From: Clifford Dorse <Clifford.Dorse@capetown.gov.za>
Sent: Thursday, 20 February 2025 17:20
To: Corlie Steyn; Lewine Walters; julia.wood
Cc: Wynand Loftus; Nasief Allie; Ammaarah Baradien; Neeren Govender; Christopher Thando Norman; Keith Wiseman; marcel.woodman; Marianna Taljaard
Subject: RE: Macassar: Meeting 20 February: Revised comment from BMD

Subject: Macassar: Meeting 20 February: Revised comment from BMD

Comment received from DEA&DP on 14 February 2025 asked specifically that a revised comment must be obtained from the City of Cape Town: Biodiversity Management Department (BMD) in reference to the quoted section below:

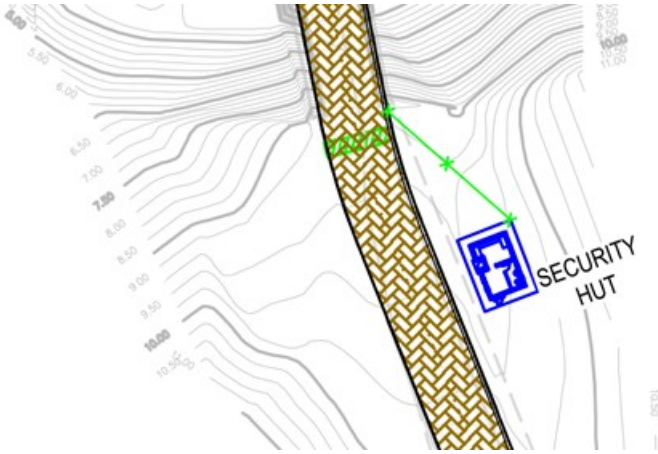
Zutari can also confirm that the request for the 2-meter-high fencing can be accommodated from the end of the bridge to the back corner of the guardhouse on the layout.

With regards to the guardhouse near the bridge for access control (Erf 708 – also reserved for EMD and Biodiversity), we can confirm that it is indeed correctly located in the layout plan. We are pleased that there will be no fencing along the access road through the nature reserve but would request if a small section of 2 meter high clear-view fencing, or similar, could be included from the end of the bridge to the back corner of the guardhouse to ensure pedestrians have to walk past the control point and to ensure the staff manning the gate house. This <20 meter section is indicated by the red line below:

This <20-meter section has been amended on the final layout plan (snippet below) and the project description of the Final BAR has been updated to reflect this change.
